FNDC - PROPOSED DISTRICT PLAN

COASTAL ENVIRONMENT, NATURAL CHARACTER & OUTSTANDING NATURAL LANDSCAPES

FOR: FAR NORTH DISTRICT COUNCIL

5 July 2024

Figure 1 Proposed Maori Purpose Rural Settlement zone taken from p12 of the submission

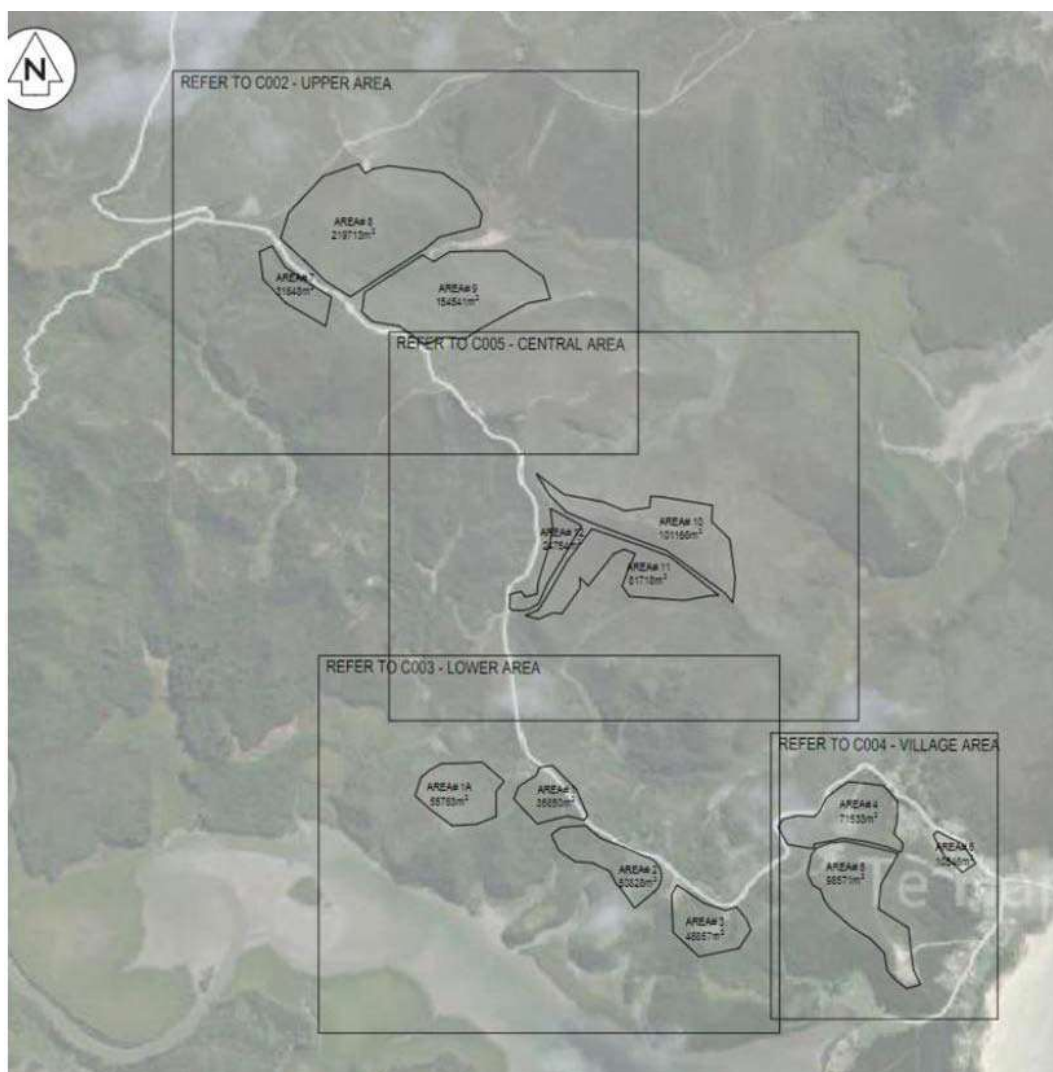
Specifically, in s420.007 they seek removal of the ONL overlay from that part of their land that they propose be re-zoned Māori Purposes Rural Settlement zone, illustrated in **Figure 1** below. Having carefully reviewed the PDP maps relating to Te Hāpua, I can confirm that there are no ONLs over the area illustrated.

Figure 2 Excerpt from PDP maps with ONL overlay over aerial photography. The forestry areas referred to above are highlighted in blue

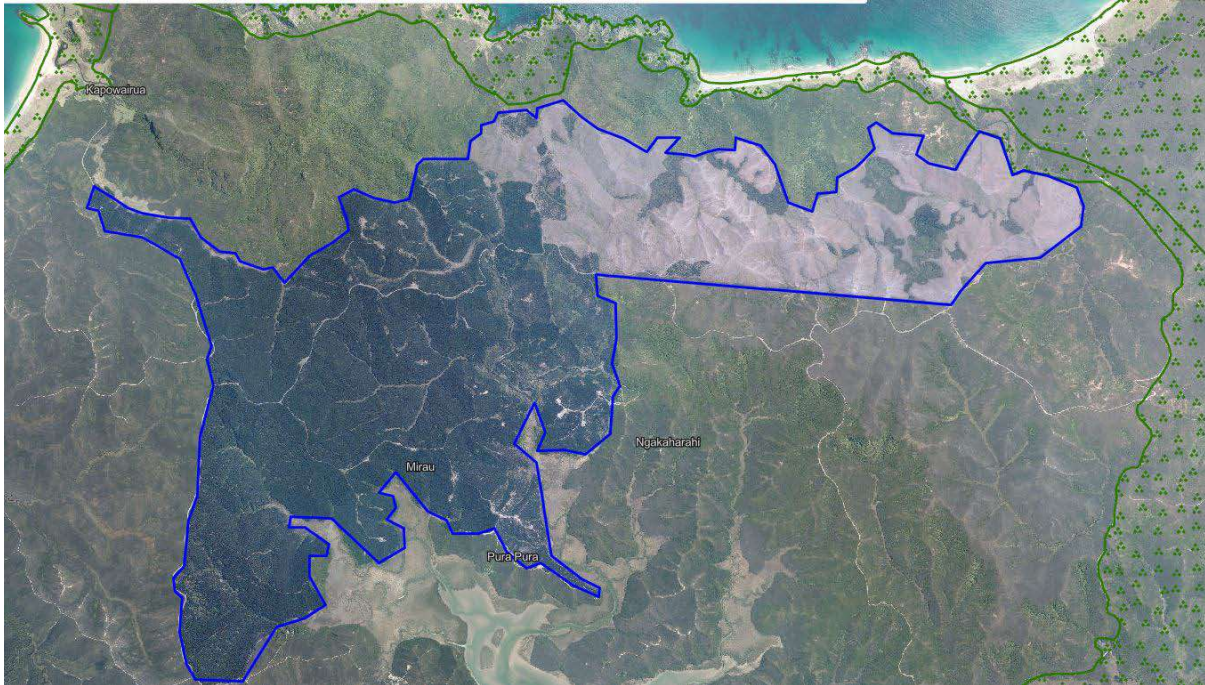
Submission point s420.009 seeks the removal of the ONL "from that part of the Te Hāpua and Shenwood Forests that is greater than 500m from the coast." Although not defined in the submission, the areas of forestry referred to would appear to be those lying immediately east of Spirits Bay Road, as illustrated in the polygon in **Figure 2** below.

As can be seen, there is no ONL overlay over the areas of forestry.

Figure 3 Area Matauri Trustee Limited requests be removed from the CE

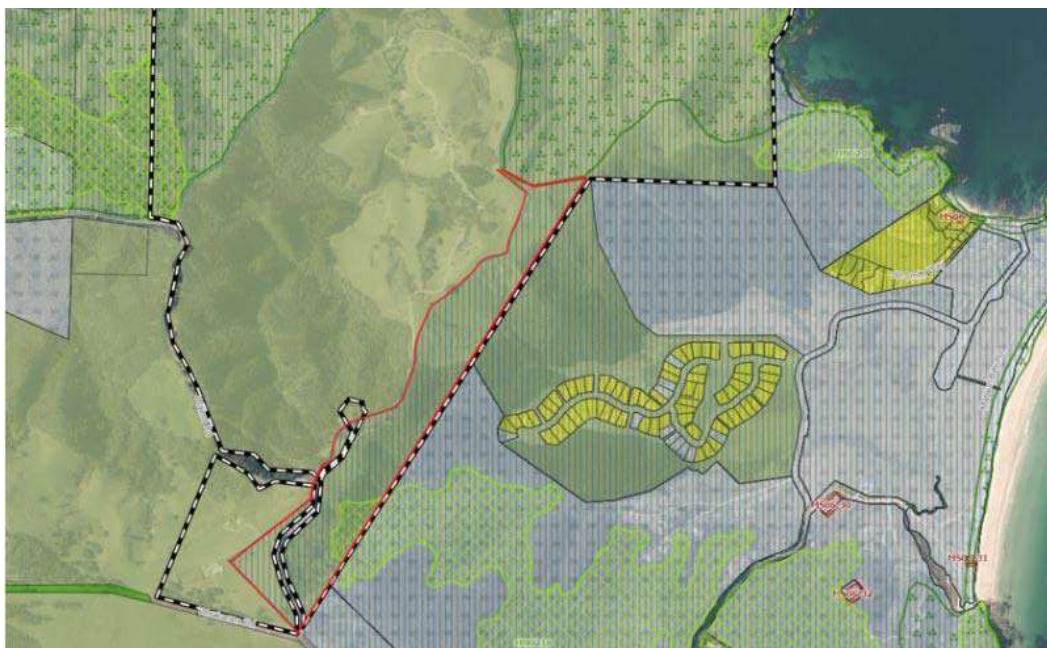
This submitter seeks that the CE overlay on part of their property be removed. The map **Figure 3**, below, shows the area where they seek the CE overlay removed outlined in red:

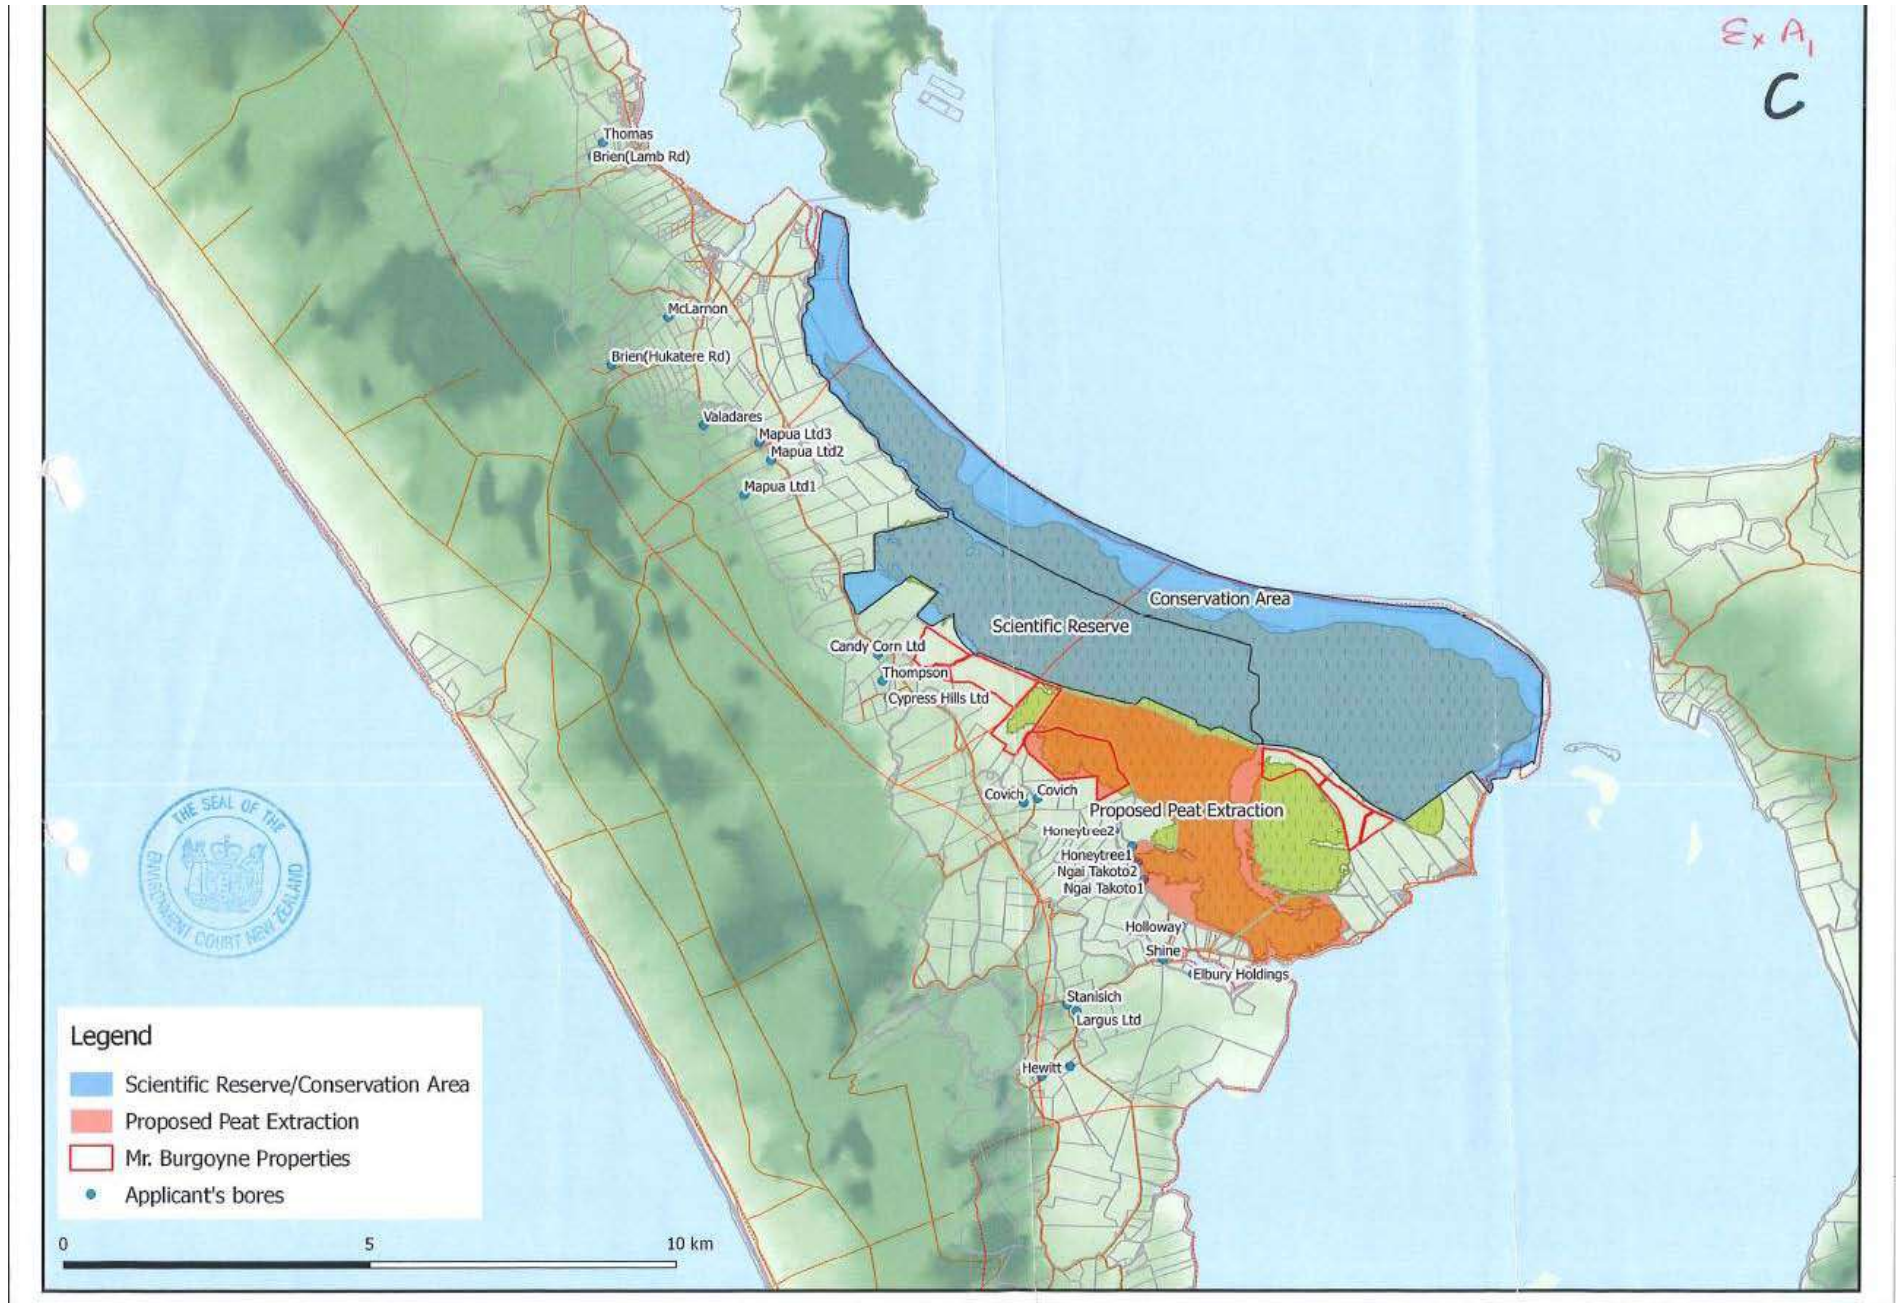
The Map B referred to in the decision is included overleaf. The key on the map shows that the topography of the wetland in metres above sea level is illustrated in bands of colour.

The landward edge of the CE as mapped in the RPS and PDP appears, from aerial photography, to follow a change in vegetation type or height and sits more or less consistently at about 1km from the coastal edge.

Given this decision, I support this submission point and suggest that, at least, the whole of the Conservation Area and Scientific Reserve areas should be included in the Coastal Environment overlay.

Figure 4

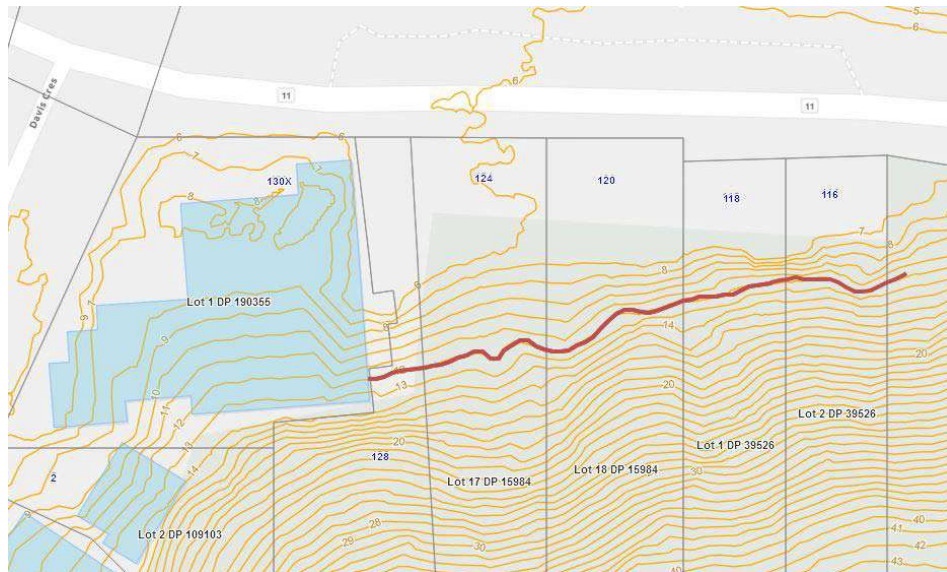
As can be seen from the two maps overleaf, the edge of HNC 426 does not extend down to the bottom of the coastal escarpment but leaves the bottom vegetated slopes free of the overlay.

Figure 4 below shows the site and 12m contour in red, as shown in the FNDC property and land maps.

Figure 7 *Is the new building 'higher' than the ridgeline or not?*

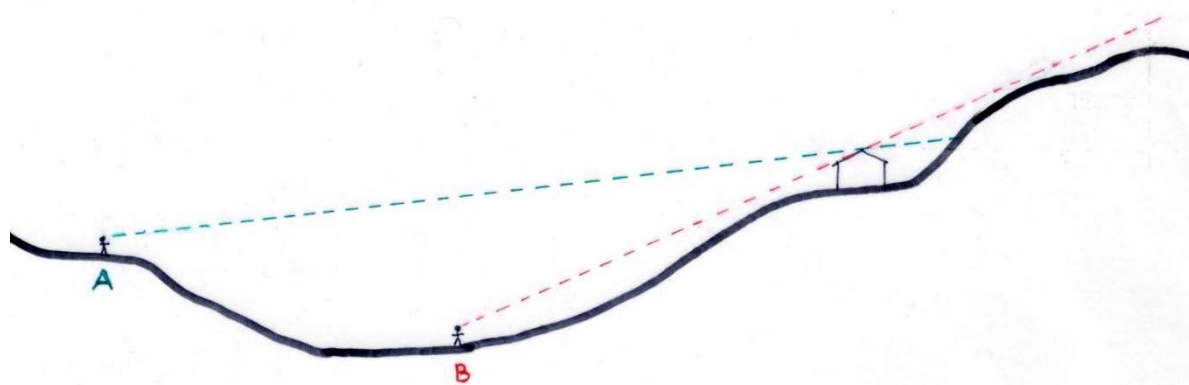
In example b. above, although the actual height of the structure may be appropriate in relation to local landform features, the specific location of a viewer, in relation to these two features, will be determinative in whether the building "appears" higher than the particular landform or not. I include **Figure 7**, below to illustrate what I mean.

The farm shed in **Figure 7** above has been constructed so that the highest point is below the crest of the nearest ridge. For viewer A the ridge successfully provides a backdrop to the building. However, for Viewer B the angle of view means that the building has no backdrop provided by the ridge and may appear on the skyline 'above' the ridge.
